**ENGINE FUEL AND CONTROL - LP/HP FUEL PUMPS - INTRODUCTION OF A REVISED LP/HP
FUEL PUMP WITH REDUCED GEARSHAFT BENDING**

V2500-ENG-73-0143

NO. 5008735-73-003

ENGINE - FUEL AND CONTROL - MODIFICATION OF LP/HP FUEL PUMPS IMPELLER/INDUCER AND CENTER PLATE

Figure 2

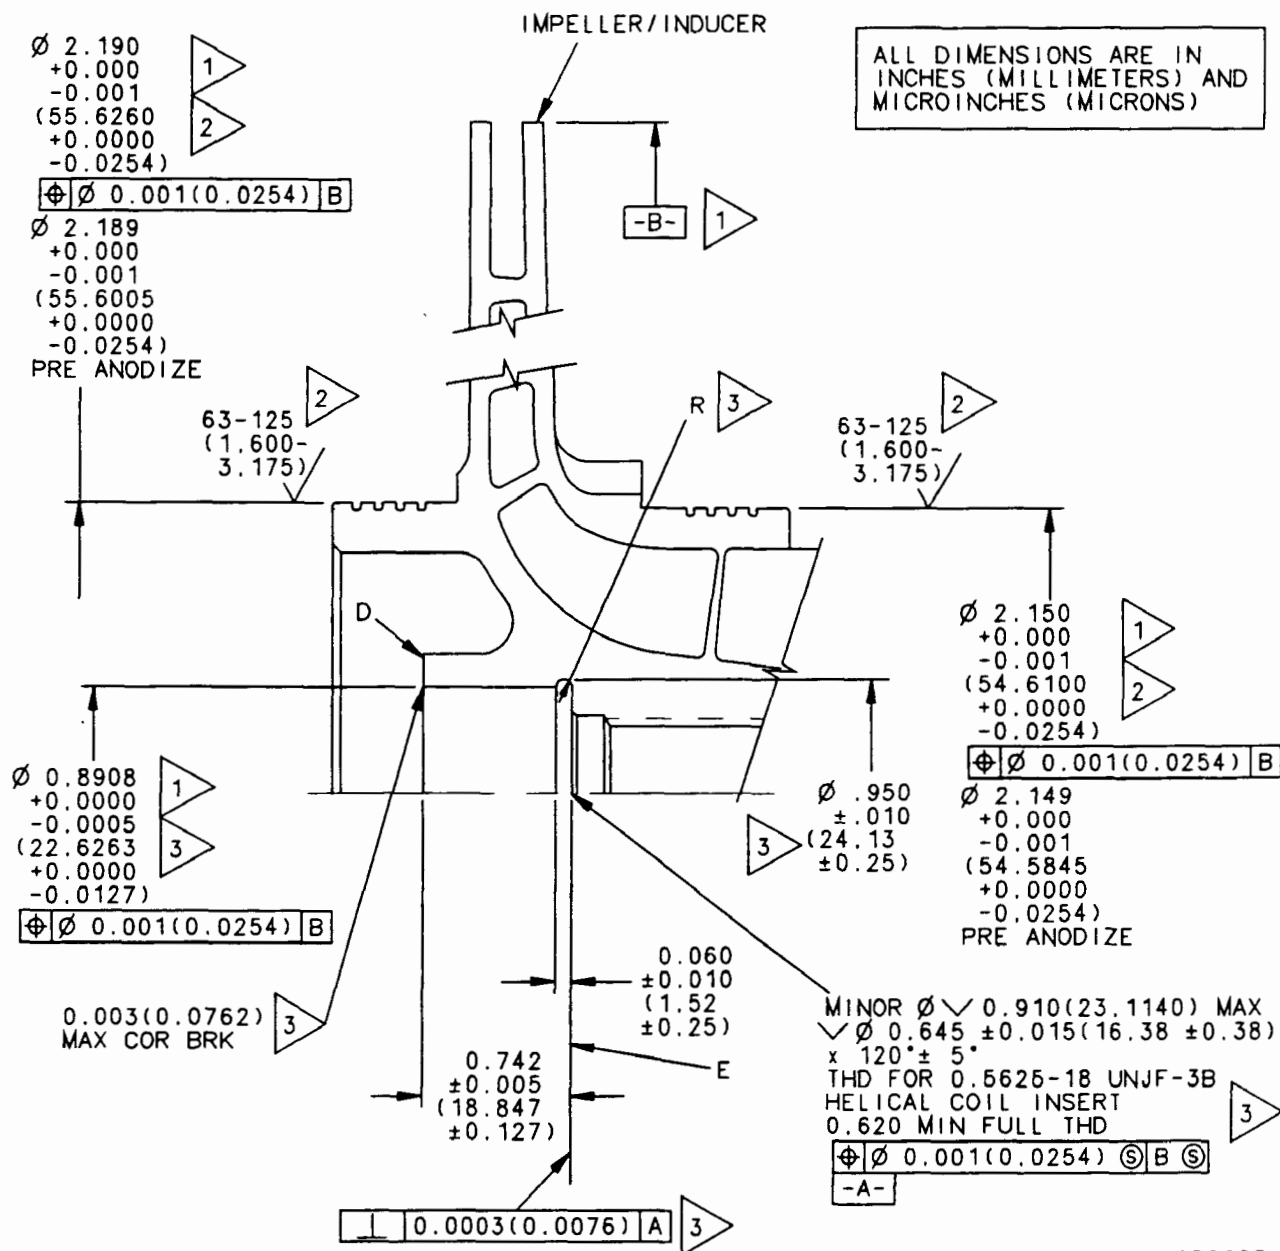
- B. Machine the impeller inducer (refer to Figure 2 of this bulletin).
- C. Measure labyrinth surface finish. If it is more than 32 micro inch (0.813 micrometer) Ra, or if it is already worn and anodize has been removed, do not perform steps C. and F.

- D. Machine off anodized layer of two labyrinth outside diameters to diameters in Figure 2 of this service bulletin to roughen it up to 63-125 micro inch (1.600 to 3.175 micrometer) Ra finish.

- G. Anodize two labyrinth outside diameters according to MIL-A-8625, TYPE 3 (Refer to Figure 2 of this service bulletin) to build up 0.001 to 0.002 inch (0.026 to 0.050 millimeter) diameter.
- H. Install helical coil insert (P/N MS124661) 1 to 1-1/2 pitches below the entering surface, taking care not to damage the entering surface, and install spacer (P/N 767998).

- I. Perform inspection for run-out [refer to paragraphs 2.C.(1) through 2.C.(3) of this bulletin]. Remachine surface E of Figure 2 until run-out is satisfactory.

Modification of Center Plate Assembly
Figure 4

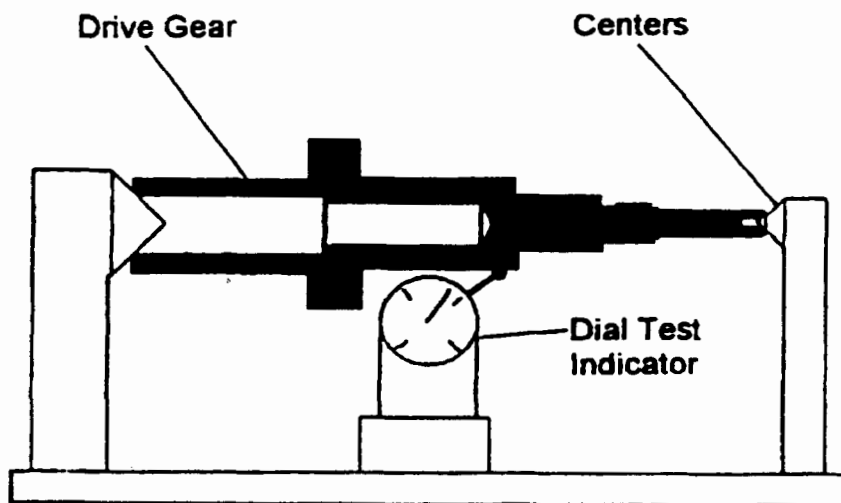
- A. Machine carbon ring in center plate. (Refer to Figure 4 of this service bulletin).
- B. Clean according to SPM Bulletin 985, CLEANING, or cleaning instruction of CMM 73-18-42.

**Inspection of Drive Gear and Impeller/Inducer
Figure 5**

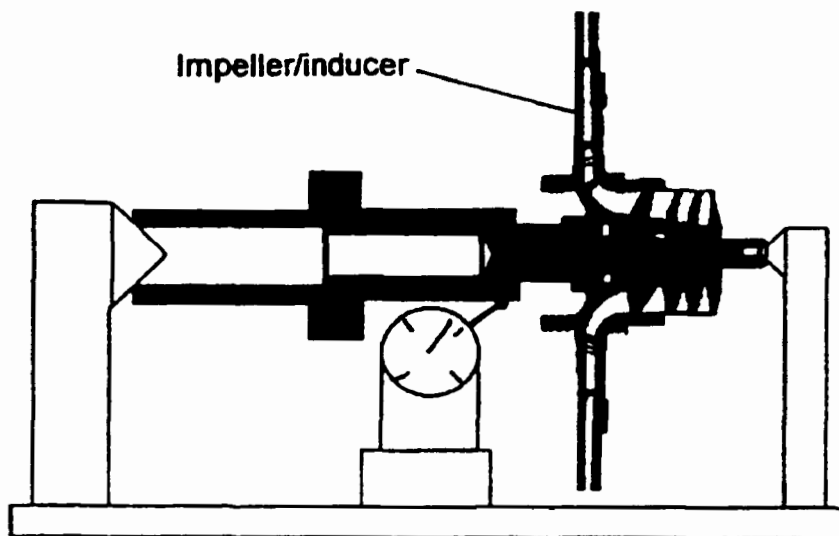
- (1) Assemble the drive gear on centers and measure the run-out of the journal nearest the impeller/inducer mounting thread according to Figure 5 of this service bulletin.

- (2) Attach the impeller/inducer to 170 pound-inches (19.3 Newton meters) torque above run-on torque and repeat step (1).
- (3) If the run-out in step (2) is greater than step (1) by 0.0007 inch (0.0178 millimeter), replace the impeller/inducer and repeat the above.

- (5) If the run-out is still bad, repeat steps (1) to (3) with a drive gear from another matched set or another impeller. If the run-out is consistently bad, remove sleeve and washer and remachine bore and shoulder concentric and perpendicular to the thread. Repeat above. If the run-out is satisfactory with the different drive gear, then return the original gear set to Hamilton Sundstrand for investigation.
